### Amendments to Code of Practice for Foundations 2017

**Amendments to the Code of Practice for Foundations 2017**  
**( July 2022 )**

Amendments to the Code of Practice for Foundations 2017 (July 2022)

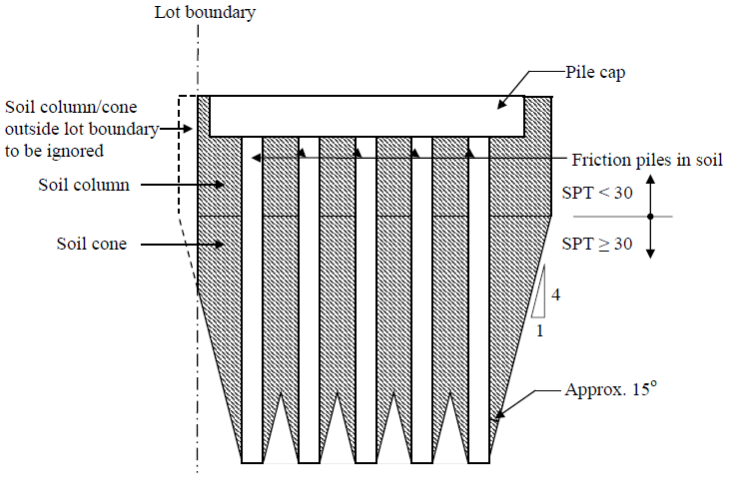
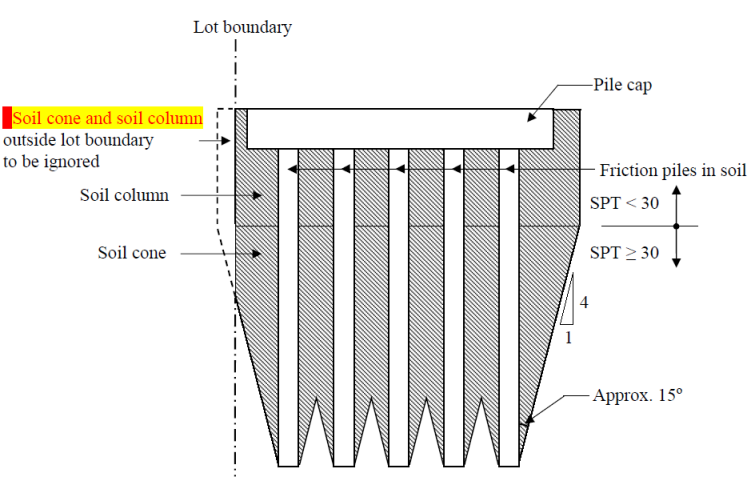
Item	Current version	Amendments
<p>4. Figure 5.1<sup>6</sup></p>	<p>(a) Single Rock Socketed Piles</p> <p>(b) Group of Closely-Spaced Rock Socketed Piles</p> <p>Figure 5.1 Configuration of Rock Cone/Soil Column for Rock Socketed Piles</p>	<p>(a) Single Rock Socketed Piles</p> <p>(b) Group of Closely-Spaced Rock Socketed Piles</p> <p>Figure 5.1 Configuration of Rock Cone and Soil Column for Rock Socketed Piles</p>

<sup>6</sup> Clarification on the assessment concerning the rock cone and soil column.
